19101-02-001

**Knocktopher to Ballyhale
Footpath Scheme**

ROAD SAFETY AUDIT STAGE 1

December 2019

Project Title: KNOCKTOPHER TO BALLYHALE FOOTPATH			
Drawing Title: PROPOSED LAYOUT (SHEET 2 OF 2)			
Drawn by: BD	Sheet Size: A1	Scale: 1:500	Date: Oct '19
Drawing Number: 19101-01-0003		Revision: -

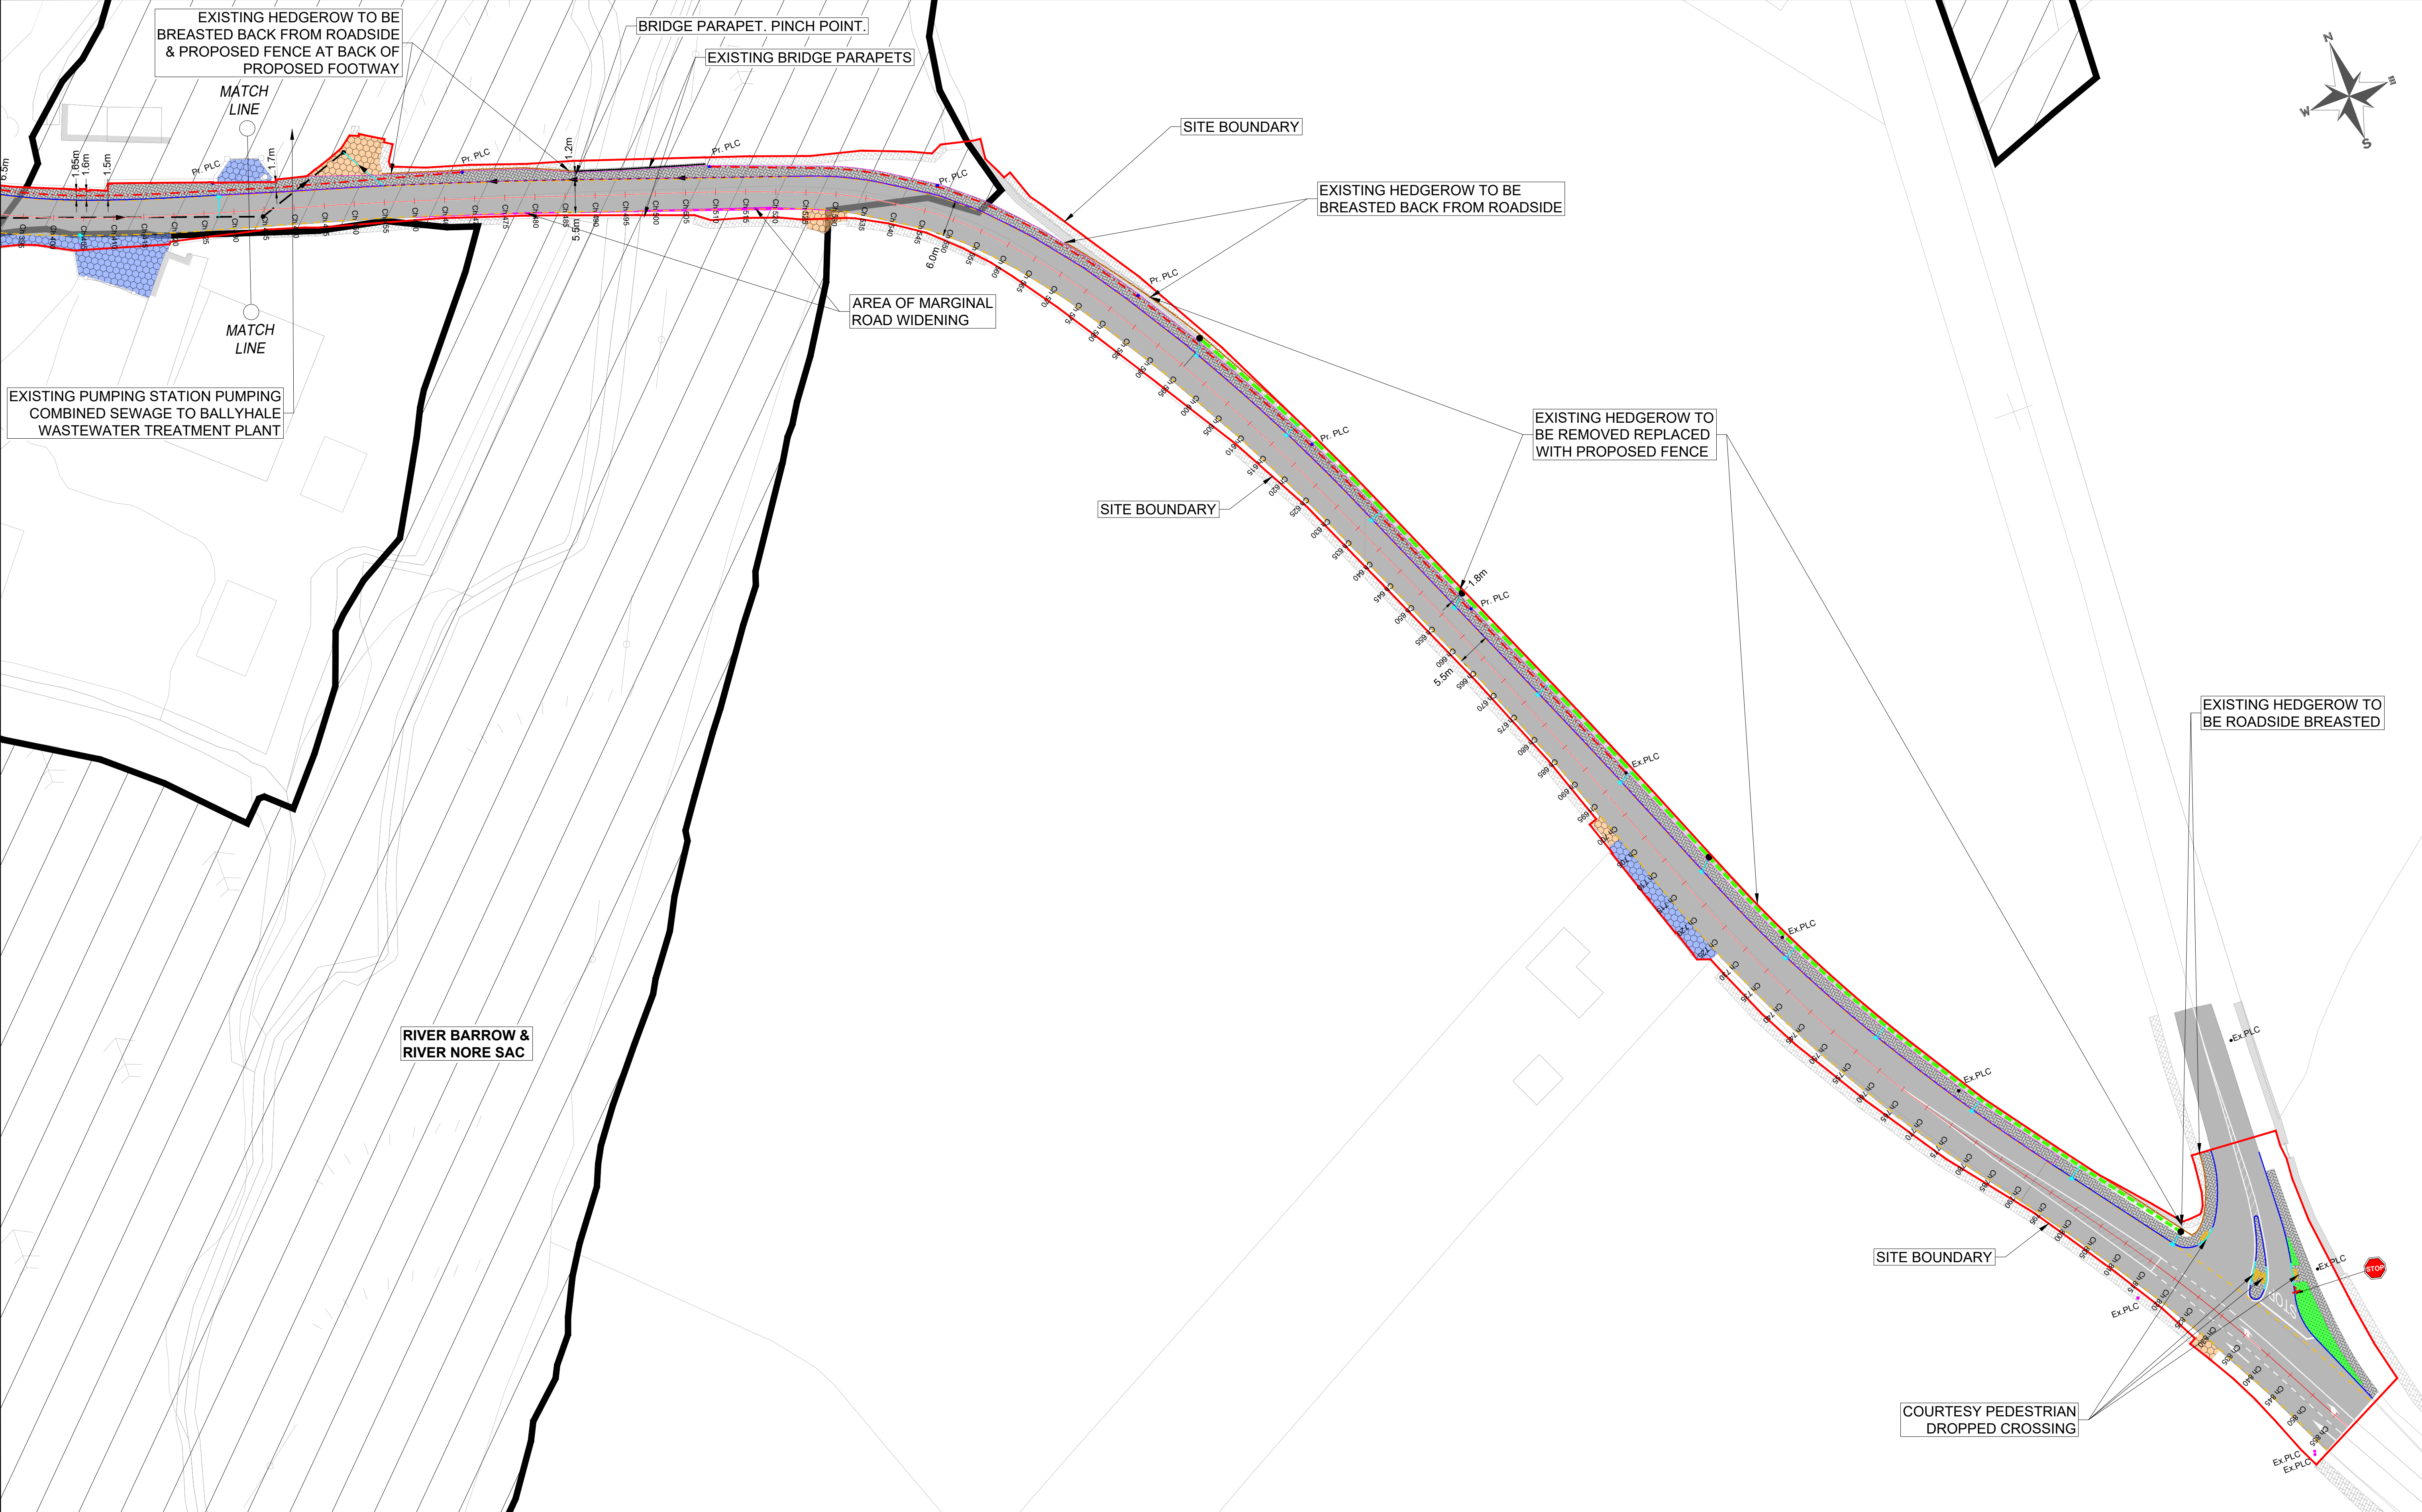
There are two locations where public lighting columns are located where the footpath is 1.5m or less wide, chainage 388 and chainage 510. If these poles are not located correctly at construction stage, they may impede pedestrians.

The existing chevron signs at chainage 545 are misleading to drivers and are not necessary in a 60 km/h speed limit zone.

The existing public lighting column at chainage 694 appears to be leaning towards the road and may be at risk of falling putting pedestrians and drivers at risk of injury.

There is a junction warning sign at approximately chainage 710. It is not clear whether this sign will be in the footpath, where it may be an obstruction to pedestrians, or be moved to the back of the footpath.

The tactile paving on the junction splitter island does not appear to line up with the tactile paving on the footpaths. Visually impaired pedestrians will be at risk of injury if they are not directed correctly.

The new footpath continues north along the edge of the R448 where there is no continuity of footpath facilities or hard shoulder. This may put pedestrians who use this footpath, particularly the visually impaired, at risk of injury if they step onto the road into the path of an approaching vehicle.

Move the column to opposite side of road if possible. If not possible ensure the column is erected as close as possible to the footpath boundary.

Remove chevron signs and erect the existing advance direction signs on new poles

Replace this lighting column with a new column.

Move the sign to the back of the footpath if necessary.

Position the tactile paving to direct visually impaired pedestrians towards the footpaths.

Finish the footpath at the junction crossing.

Paragraph No. in Safety Audit Report	To Be Completed By Designer			To Be Completed by Audit Team Leader
	Problem accepted (yes/no)	Recommended measure accepted (yes/no)	Describe alternative measure(s). Give reasons for not accepting recommended measure. Only complete if recommended measure is not accepted.	Alternative measures or reasons accepted by auditors (yes/no)
2.1	Yes	Yes	-	-
2.2	Yes	Yes	-	-
2.3	Yes	Yes	-	-
2.4	Yes	Yes	-	-
2.5	Yes	Yes	-	-
2.6	Yes	Yes	-	-
2.7	Yes	Yes	-	-
2.8	Yes	Yes	-	-
